INFORMATION REQUEST RESPONSE

RESPONSE TO INFORMATION REQUEST – 58 TIMOR AVENUE, LOGANHOLME (APPLICATION REFERENCE – MCUI/49/2026)

Figure 1: The approved development at 36 Timor Avenue, with 24m² courtyards.

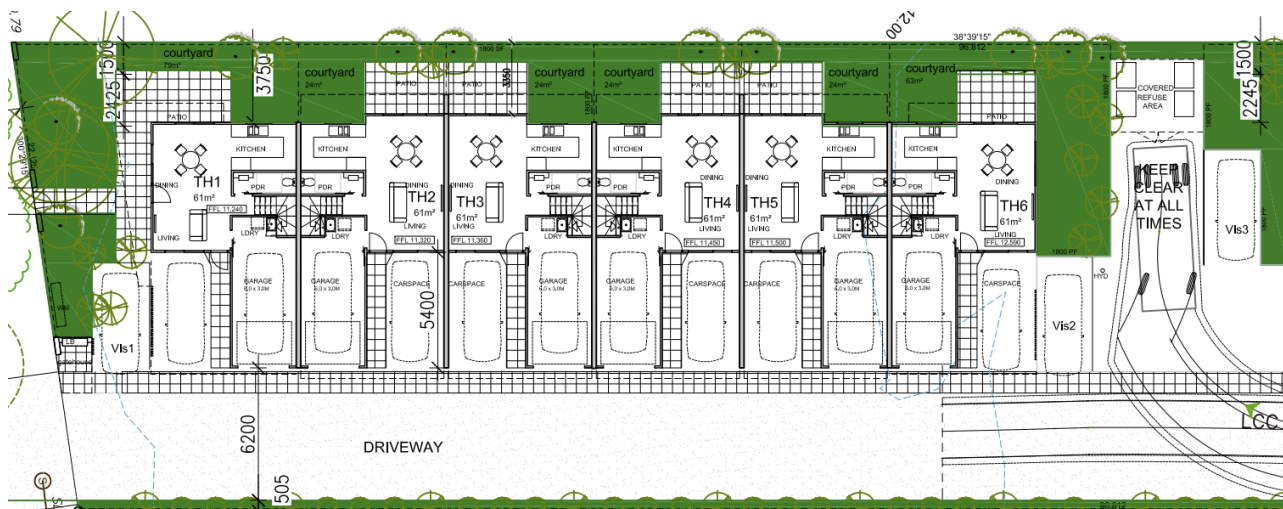
1.1. *Provide amended plans demonstrating compliance with AO/PO6 of the Multiple dwelling, Rooming accommodation and Short-term accommodation code.*

Provide 35m² of private open space for each unit, including TH5 and TH6. It is noted that while the private open space for courtyard for TH6 is noted to have a courtyard area of 26m² (as per the provided Town planning report and proposed plans of development), the landscaping plans indicate that the area to the north-east of the refuse storage area is part of the courtyard. It is recommended the application material be updated to include this area in the courtyard of TH6.

The proposed outcome is also consistent with the form of development previously accepted by Council within the surrounding area. In particular, the development approved under MCUI/37/2025 at 36 Timor Avenue, Loganholme represents a highly comparable development outcome, with the majority of approved ground level courtyards providing approximately 24m² of private open space (refer to Figure 1).

By comparison, the proposed development provides ground level courtyards of approximately 26m², representing a greater area of private open space than that provided within this comparable development. This demonstrates that private open space below 35m² can nevertheless provide an appropriate and

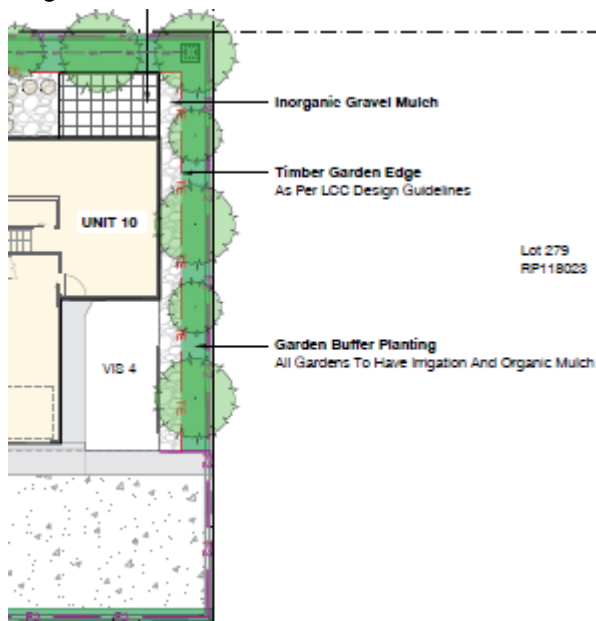
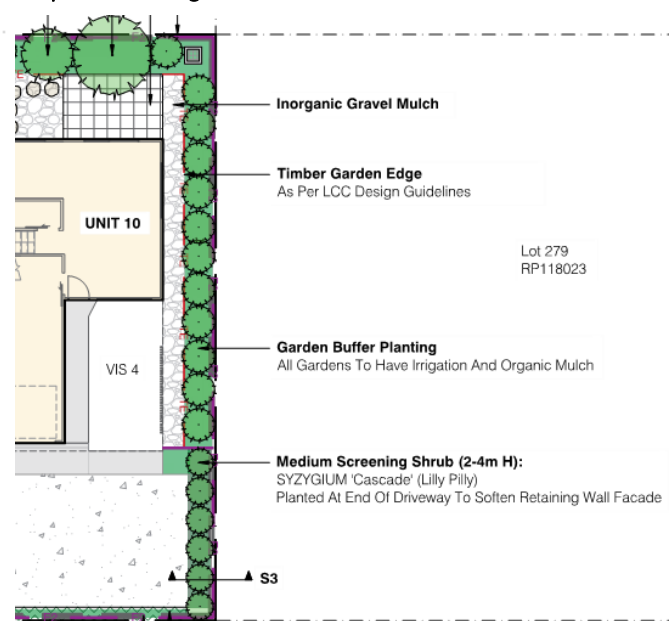
1.2. *Provide further landscaping at the end of the internal driveway to soften and screen the retaining wall (greater than 1.5 metres in height).*

Care should be taken to ensure than any additional landscaping does not compromise vehicle manoeuvring.

As shown in the comparison between the original submission and proposed changes, the extent of landscaping has increased along the rear to soften the retaining wall. Furthermore, 'Lilly Pilly' screening shrubs are now proposed, which will grow to a height of 2.0m to 4.0m, ensuring much of the retaining wall will be screened (refer to **Appendix 7**). It has been confirmed there will be no impact on maneuvering.
